Appl. No. 09/817,471
Amdt.. dated Mar. 20, 2004
Reply to Office action of Dec. 23, 2003

Amendments to Drawings:

CHANG FIGURE 4 With QIAO Additions & Subtractions

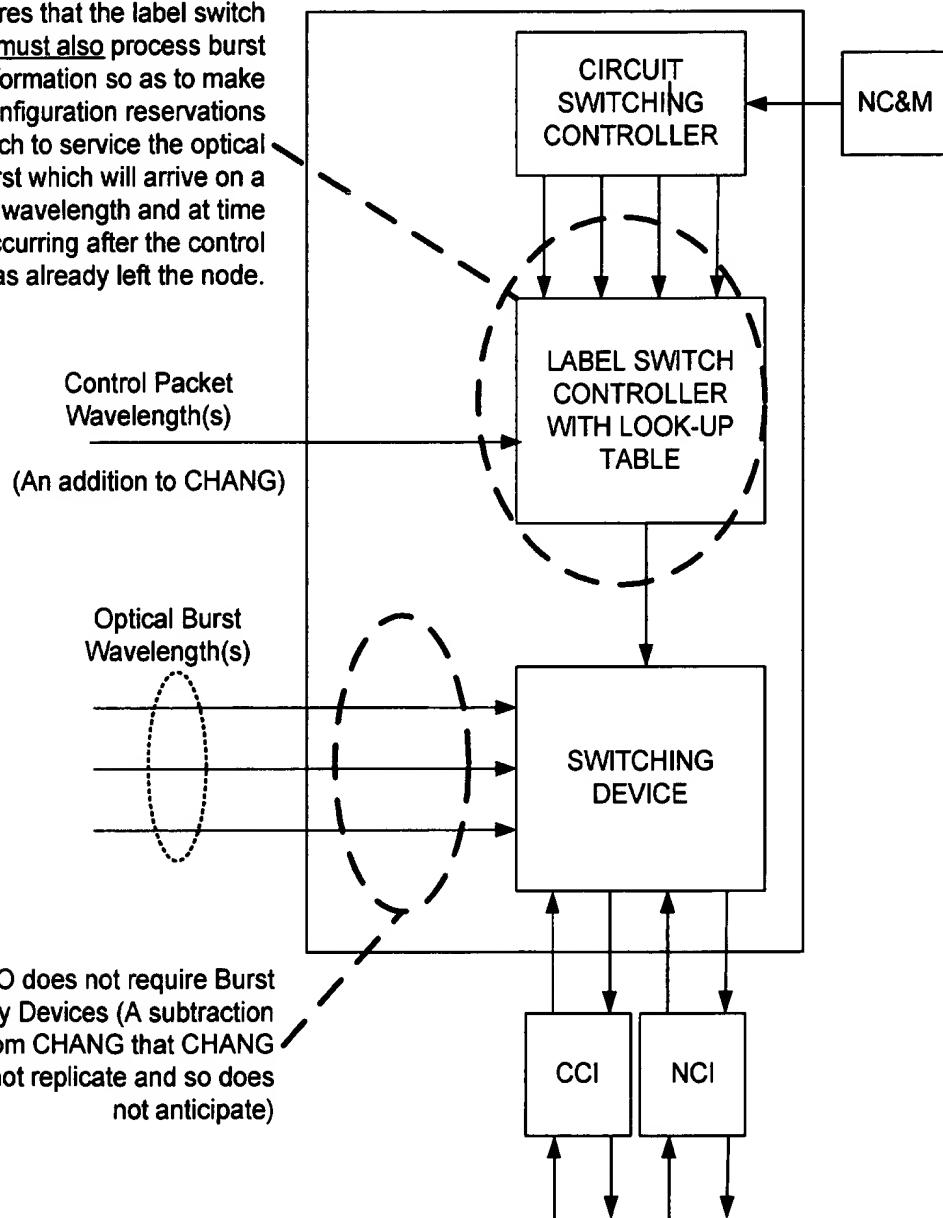
QIAO requires that the label switch controller must also process burst delay information so as to make future configuration reservations for the switch to service the optical burst which will arrive on a different wavelength and at time typically occurring after the control packet has already left the node.

QIAO DRAWING #1 (With changes annotated with additional comments)

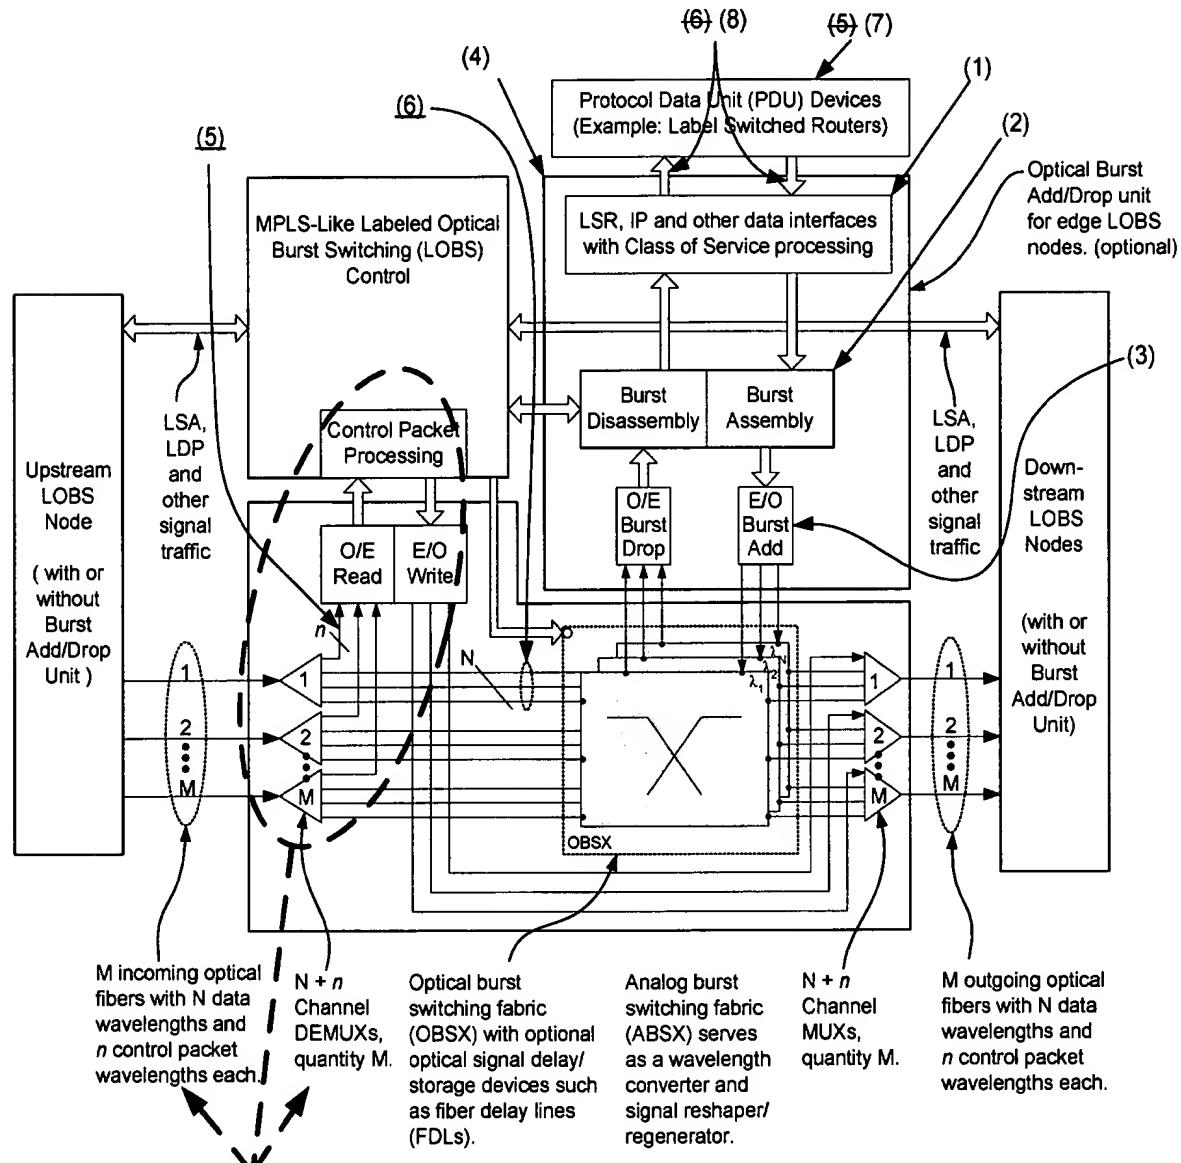
The captions and the connections shown above make it clear that (in contrast to CHANG), the Control Packet Processing is only connected to the *n control packet wavelengths (per incoming fiber)*. These wavelengths are distinct, i.e. out-of-band from the *N data wavelengths (per incoming fiber)*. QIAO also makes it clear that initial offset delays are explicitly used and communicated via the control packets and that the Control Packet Processing specifically addresses this information in determining how to control the Optical Burst Switching Fabric. Such additional processing and scheduling of bandwidth reservations within the switching device as required by the use of an initial offset between the burst and its out-of-band control packet, is not present in any IP router and so (the IP router 111, in fig. 3 CHANG) is not a sufficient art and so does not anticipate QIAO.

DRAWING 1

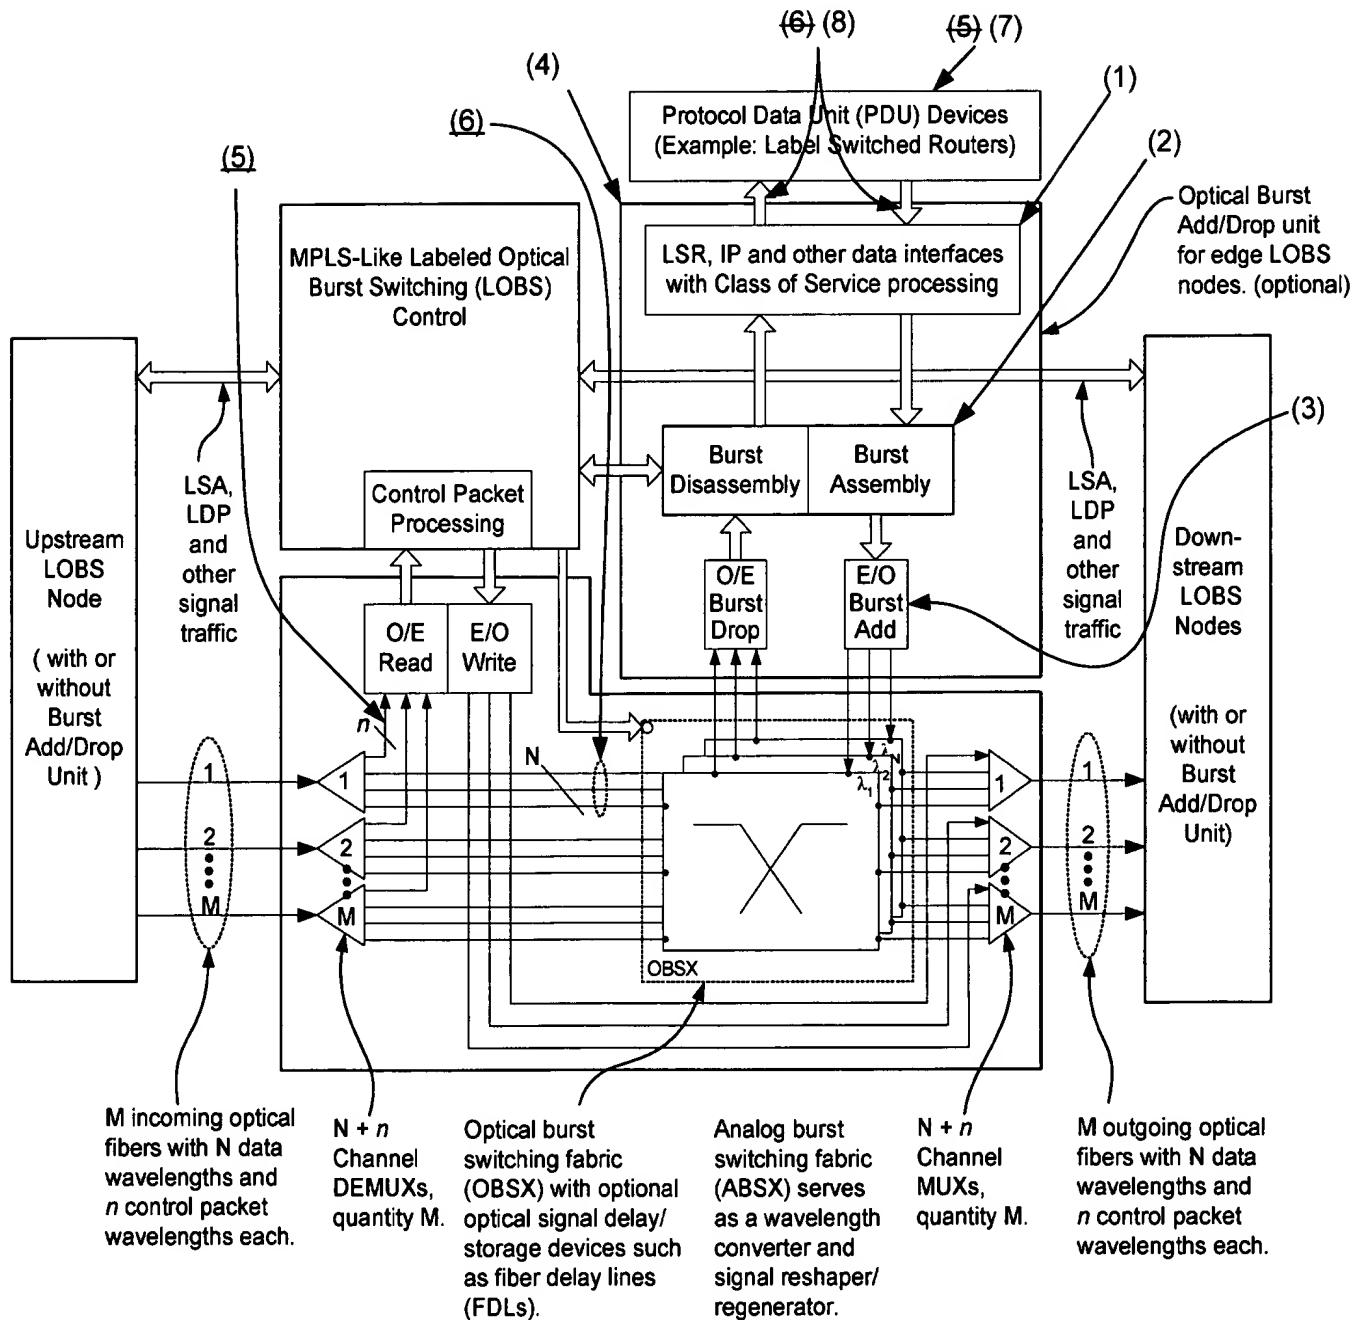
The attached sheet of drawings includes changes to Drawing 1. This sheet, which includes Drawing 1, replaces the original sheet. In Drawing 1, the previously un-labeled items of the control channels and the data wavelengths are now labeled with numbered callouts and the callouts are re-sequenced in the order of their occurrence within the specification.

DRAWING 2

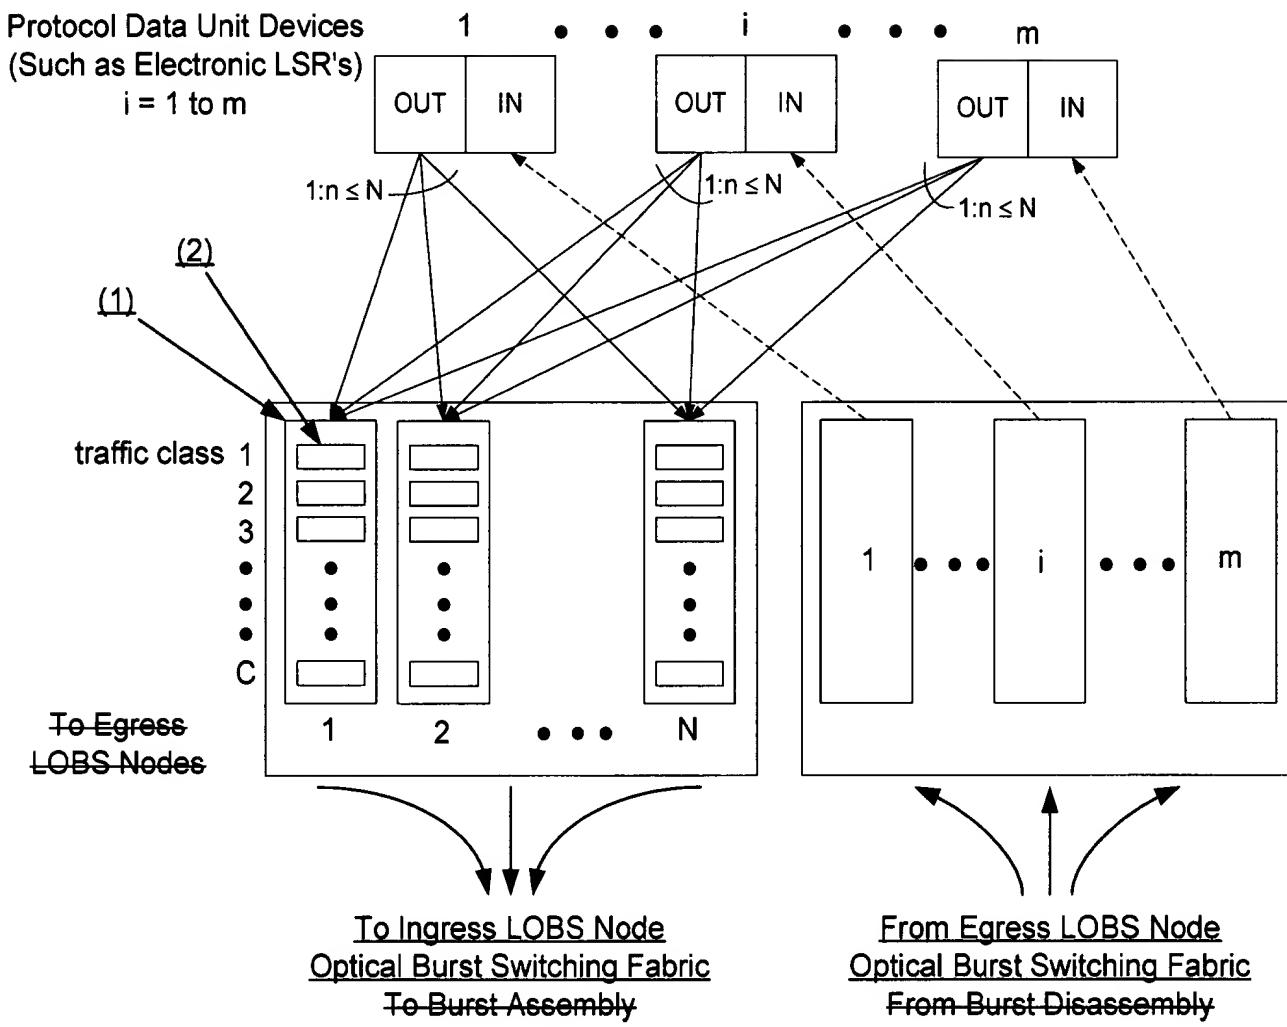
The attached sheet of drawings includes changes to Drawing 2. This sheet, which includes Drawing 2, replaces the original sheet. In Drawing 2, the previously un-labeled items of the burst assembly/burst disassembly buffers are now labeled with numbered callouts and the callouts are re-sequenced in the order of their occurrence within the specification.
